**G5-1
Build**

**G5-2
Build**

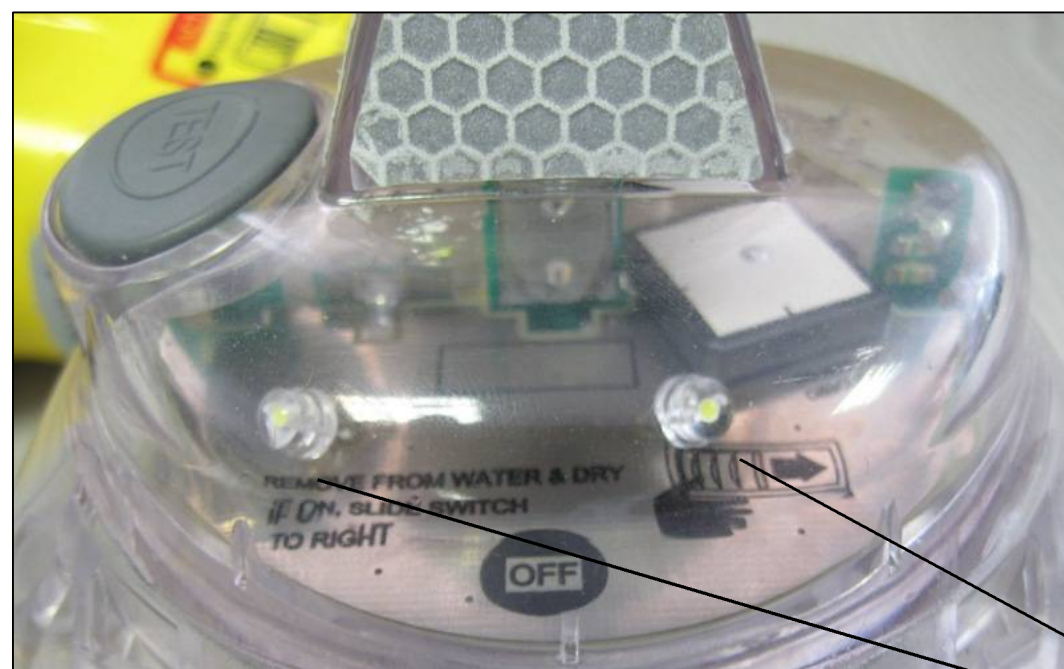
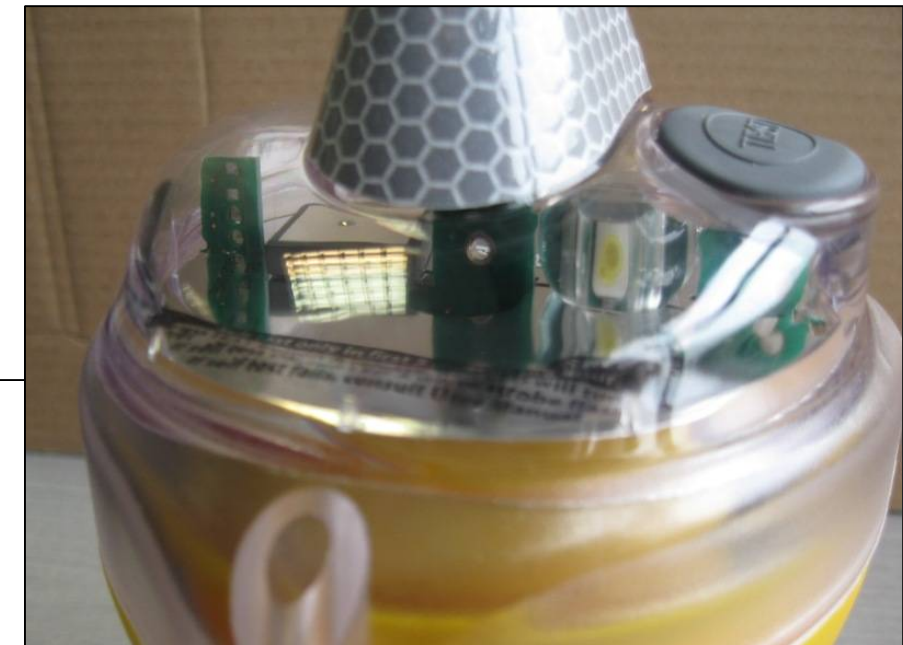
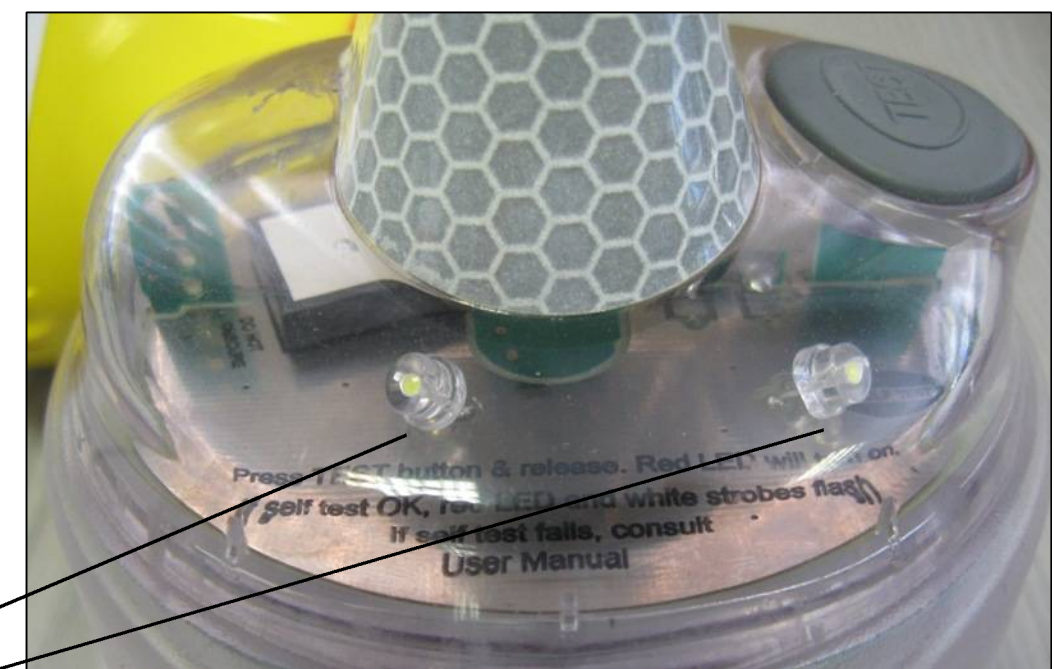
The only visible difference in the beacon body will be looking into the transparent dome moulding:

Four LEDs replace the single LED with lens for the Low-Duty-Cycle-Light function

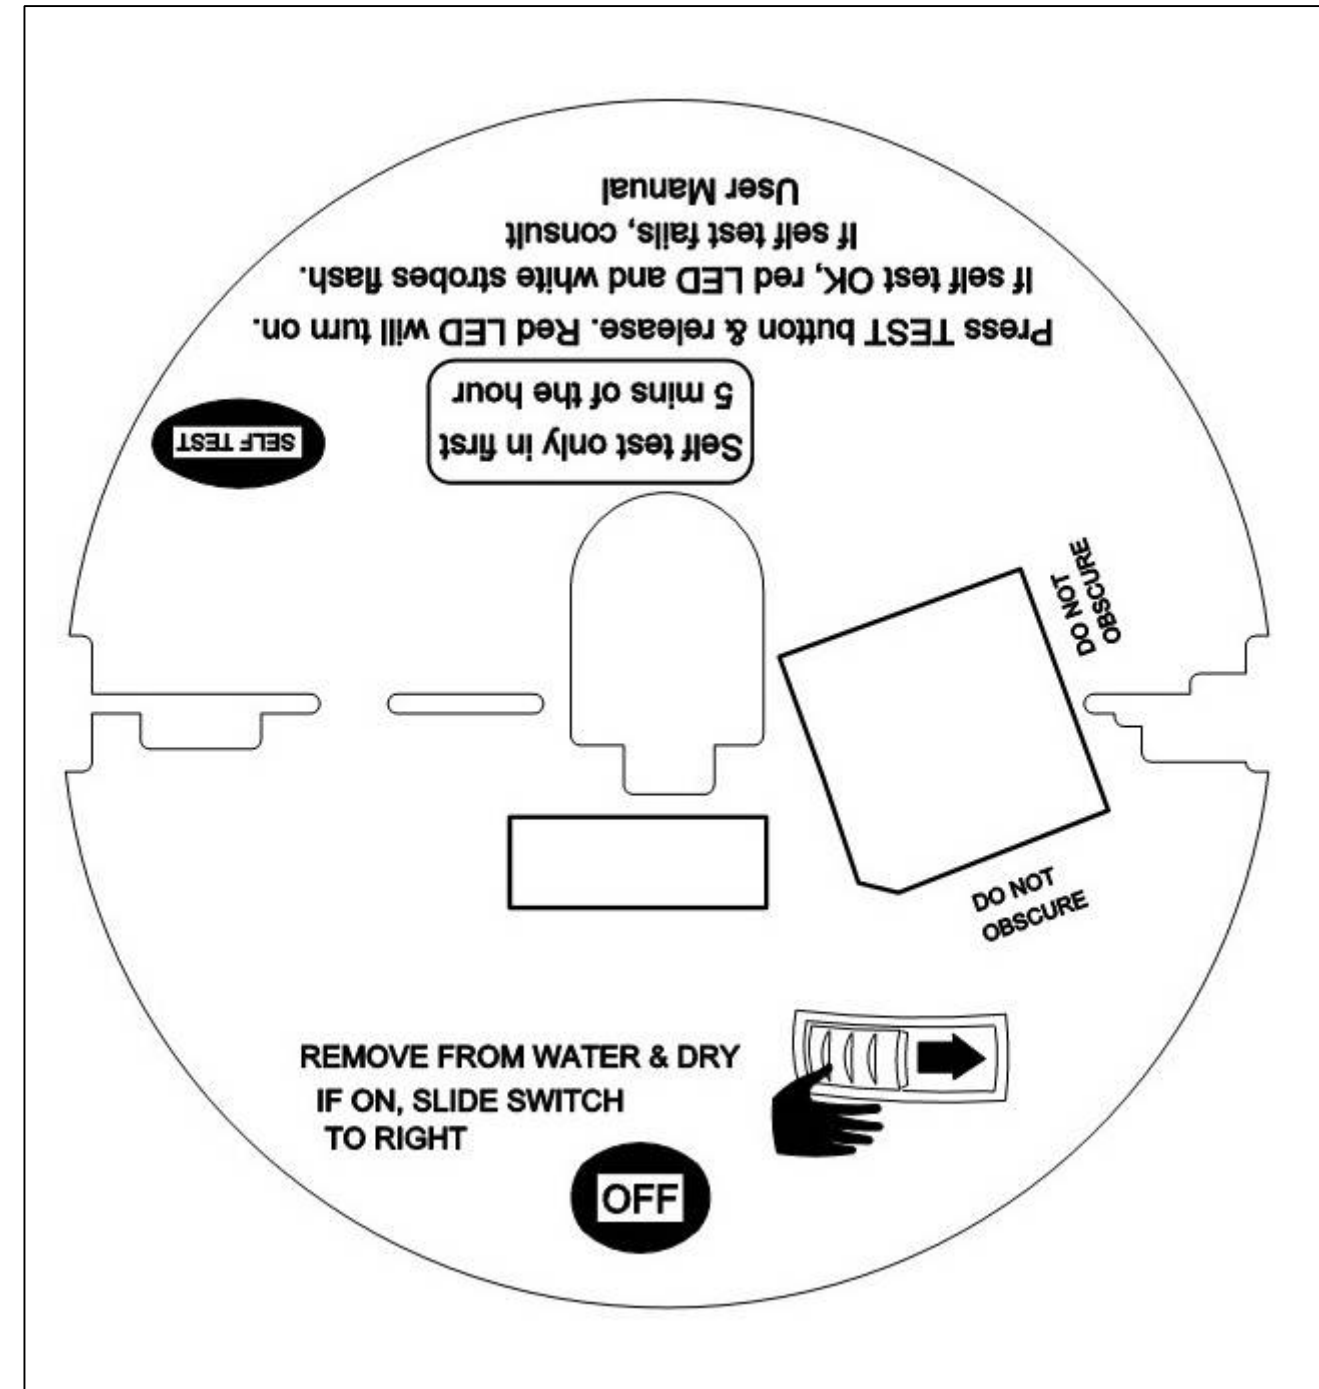
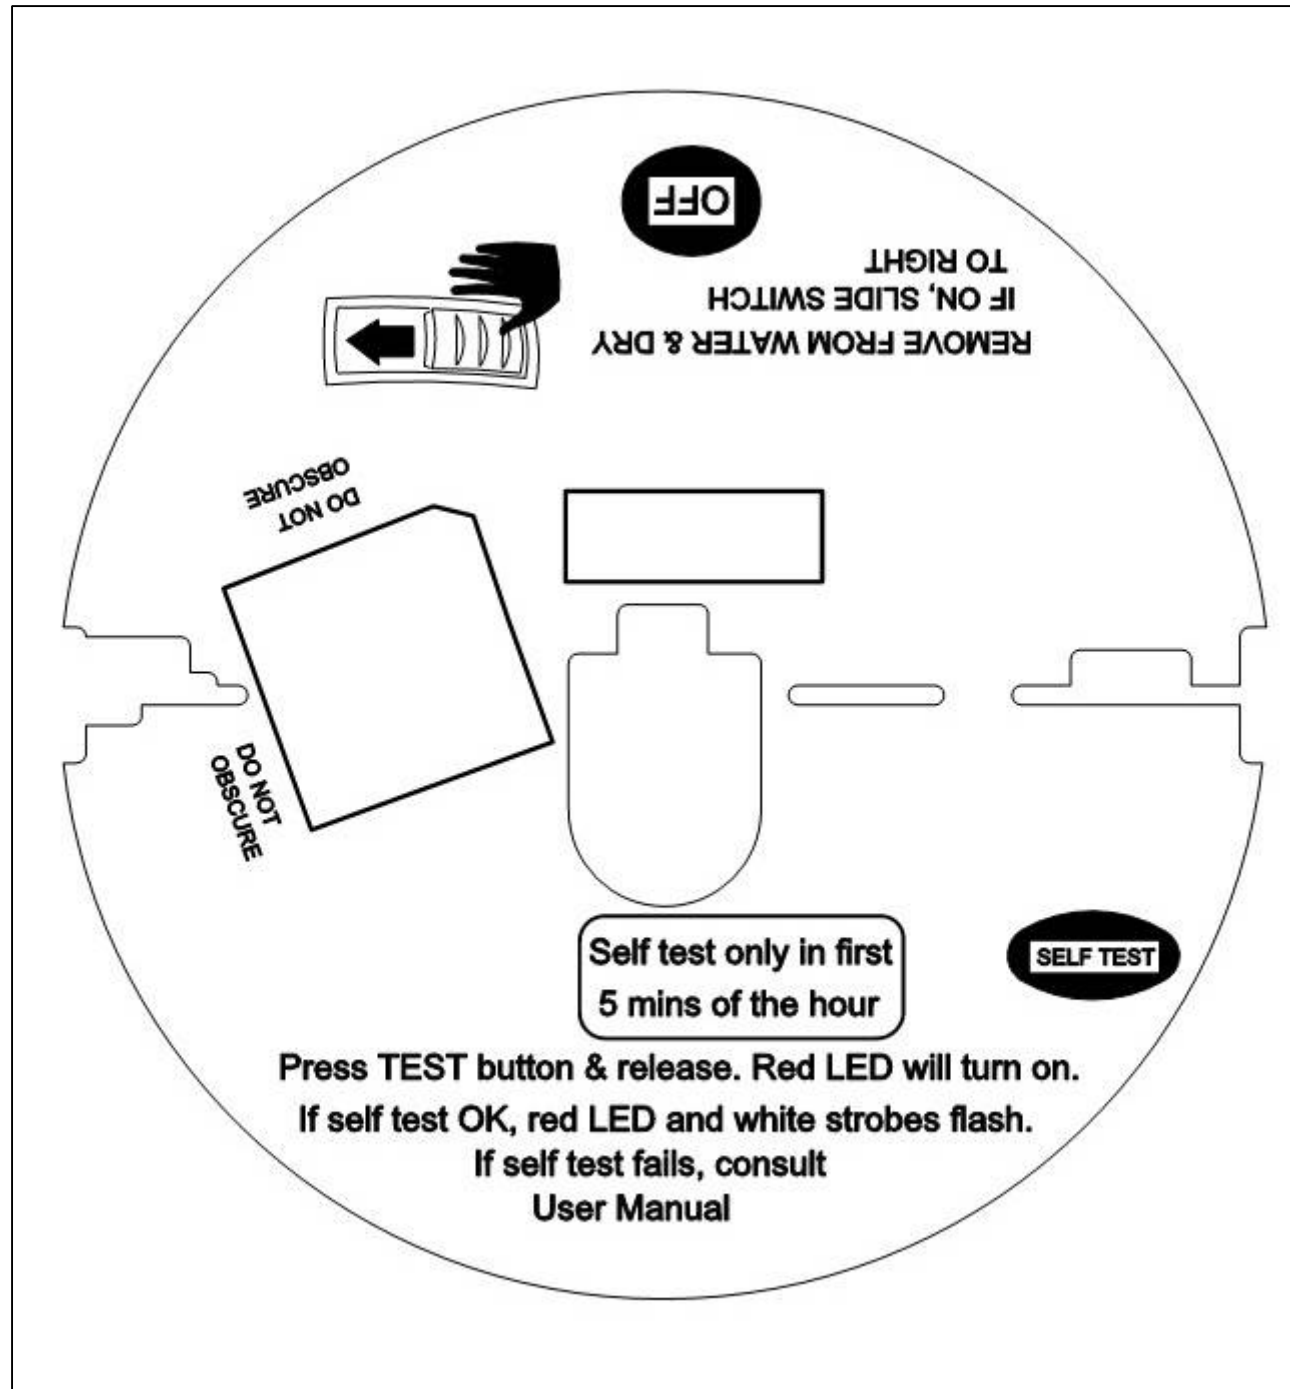
The G5-2 Build images above are from the test prototype - the top silkscreen for the production version of the disc PCB is shown below, to better illustrate the legend which will be visible looking into the transparent dome moulding:
